SUBJECT: St. Louis Regional Airport
East Alton, Illinois
Madison County
Illinois Project Number: ALN-5173
SBG Project Number: 3-17-SBGP-TBD
Contract No. SR098
Item No. 02A, April 25, 2025 Letting
Addendum A

Revising notes on the Proposed Safety and Phasing Plans.

**RECONSTRUCT
TAXIWAY B**

**PROPOSED SAFETY
AND PHASING
PLAN-WORK AREA 1**

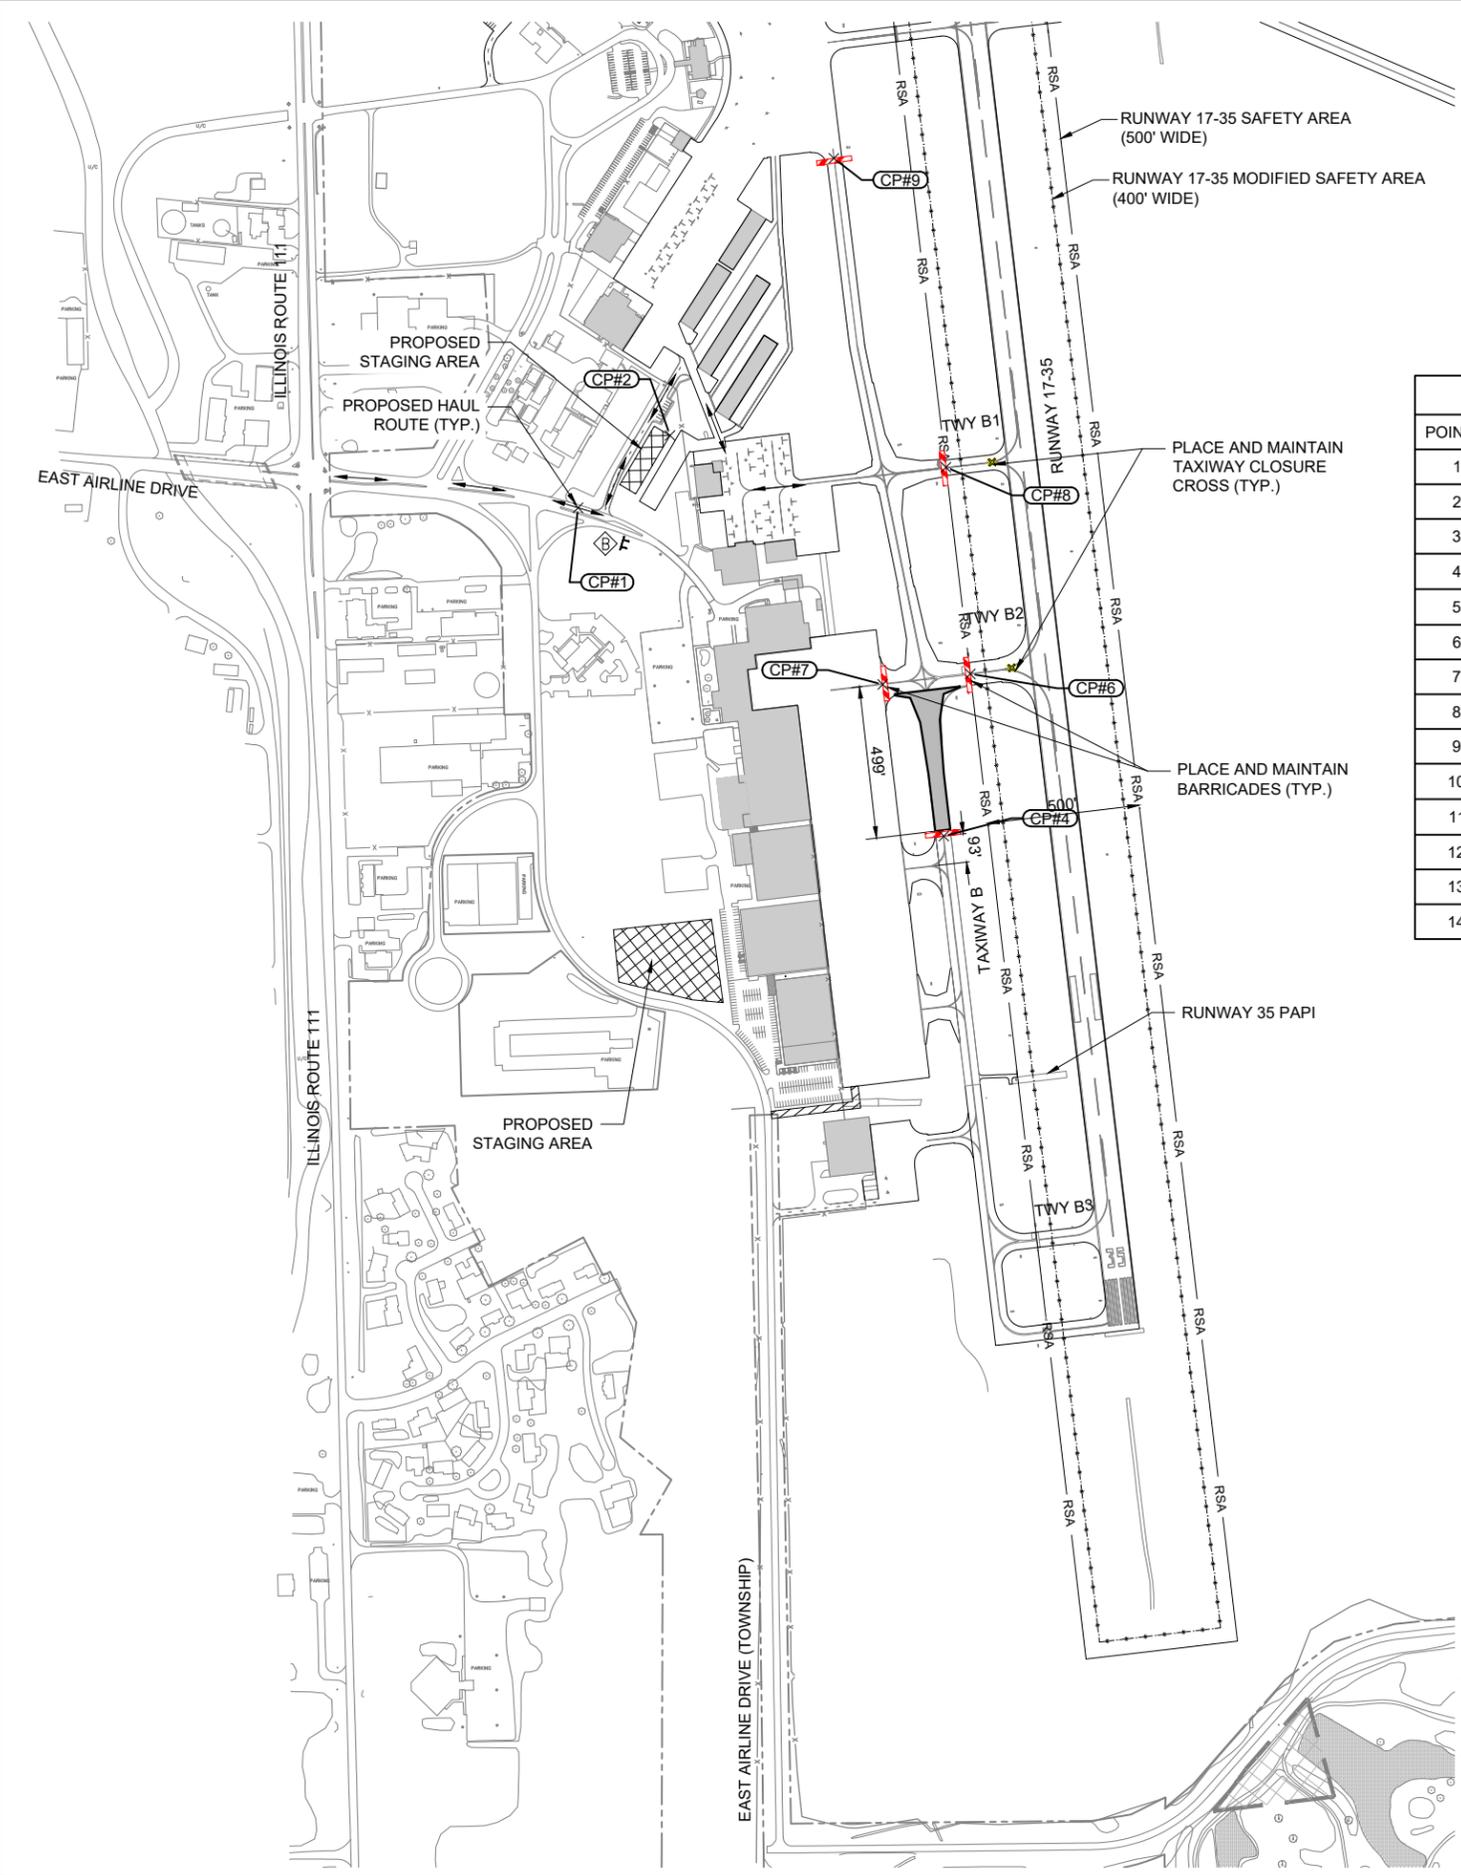
Plan Sheet 4, Proposed Safety and Phasing Plan-Work Area 1:
Revise Work Area 1 Notes, see enclosed revised plan sheet.

9. WORK WITHIN THE 500' RSA WILL BE REQUIRED DURING A SMALL PORTION OF THE PROPOSED UNDERDRAIN WORK. WHEN THIS WORK IS SCHEDULED TO OCCUR, THE AIRPORT DIRECTOR AND TOWER SHALL BE NOTIFIED 7 DAYS IN ADVANCE AND THE 500' RSA SHALL BE REDUCED TO 400' TEMPORARILY TO ACCOMMODATE THE PROPOSED UNDERDRAIN WORK.

10. THE OWNER RESERVES THE RIGHT TO ALLOW SPECIFIC AIRCRAFT OPERATIONS DURING CONSTRUCTION THAT WILL REQUIRE THE STANDARD RSA WIDTH OF 500' TO BE REINSTATED. IN THESE INSTANCES, THE CONTRACTOR WILL BE REQUIRED TO TEMPORARILY MOVE THEIR PERSONNEL AND EQUIPMENT OUTSIDE OF THE STANDARD RSA LIMITS UNTIL THE AIRCRAFT OPERATION IS COMPLETED (ESTIMATED MAX. 30 MINUTES). THE CONTRACTOR WILL BE GIVEN AS MUCH ADVANCE NOTICE AS POSSIBLE FOR EACH OCCURRENCE. THE OWNER WILL ATTEMPT TO SCHEDULE AS BEST AS POSSIBLE TO AVOID INTERRUPTIONS TO CONSTRUCTION PROGRESS.

**PROPOSED SAFETY
AND PHASING
PLAN-WORK AREA 2**

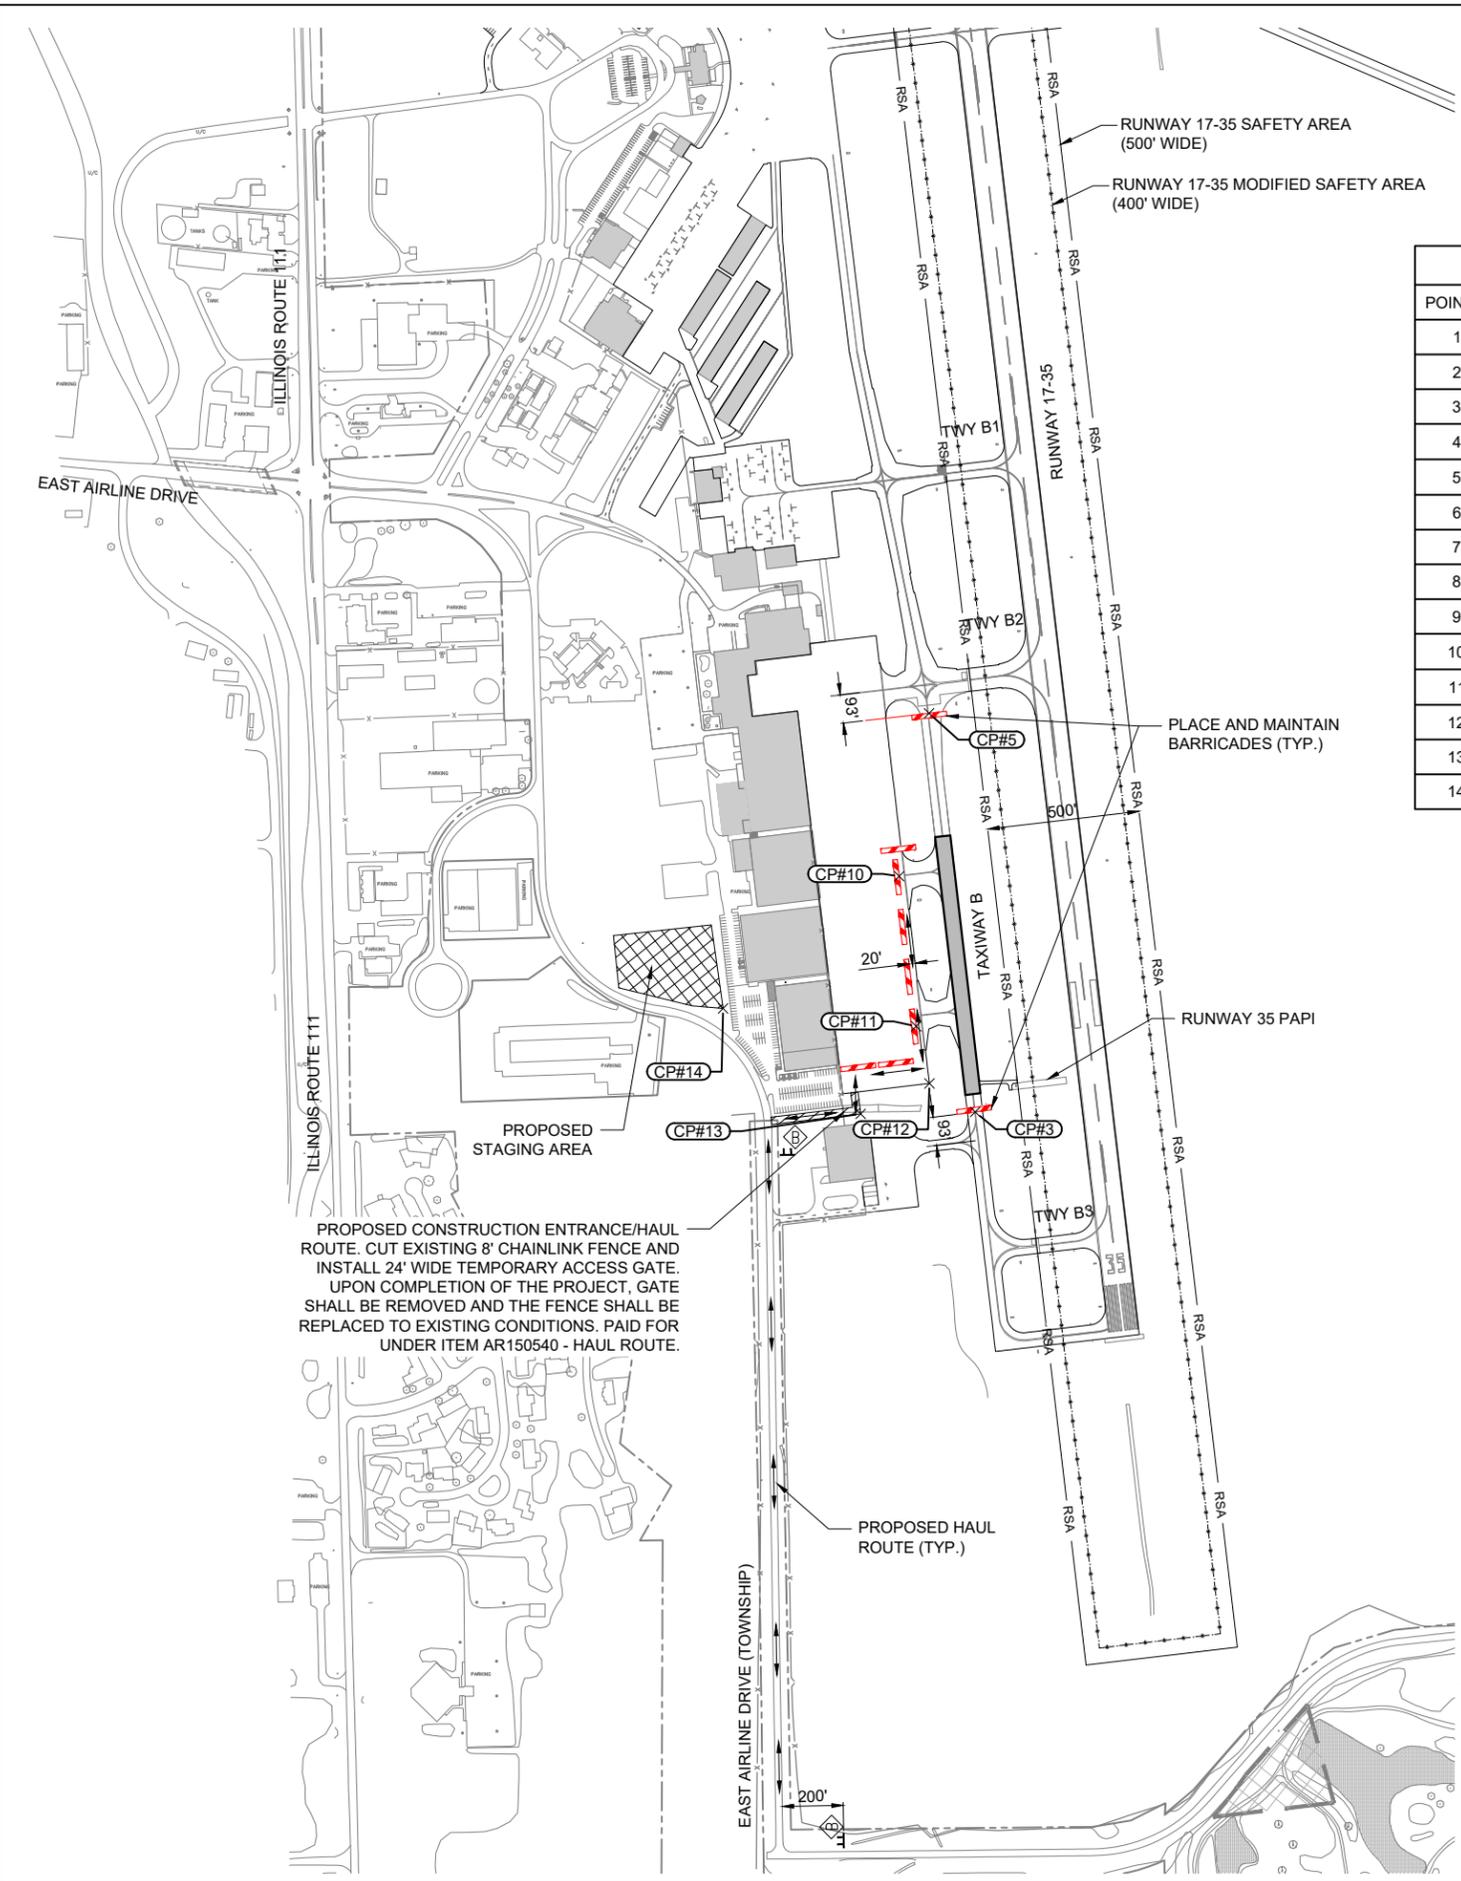
Plan Sheet 5, Proposed Safety and Phasing Plan-Work Area 2:
Revise Work Area 2 Notes, see enclosed revised plan sheet.

- WORK WITHIN THE 500' RSA WILL BE REQUIRED DURING A SMALL PORTION OF THE PROPOSED UNDERDRAIN WORK. WHEN THIS WORK IS SCHEDULED TO OCCUR, THE AIRPORT DIRECTOR AND TOWER MUST BE NOTIFIED 7 DAYS IN ADVANCE AND THE 500' RSA SHALL BE REDUCED TO 400' TEMPORARILY TO ACCOMMODATE THE PROPOSED UNDERDRAIN WORK.

- THE OWNER RESERVES THE RIGHT TO ALLOW SPECIFIC AIRCRAFT OPERATIONS DURING CONSTRUCTION THAT WILL REQUIRE THE STANDARD RSA WIDTH OF 500' TO BE REINSTATED. IN THESE INSTANCES, THE CONTRACTOR WILL BE REQUIRED TO TEMPORARILY MOVE THEIR PERSONNEL AND EQUIPMENT OUTSIDE OF THE STANDARD RSA LIMITS UNTIL THE AIRCRAFT OPERATION IS COMPLETED (ESTIMATED MAX. 30 MINUTES). THE CONTRACTOR WILL BE GIVEN AS MUCH ADVANCE NOTICE AS POSSIBLE FOR EACH OCCURRENCE. THE OWNER WILL ATTEMPT TO SCHEDULE AS BEST AS POSSIBLE TO AVOID INTERRUPTIONS TO CONSTRUCTION PROGRESS.**
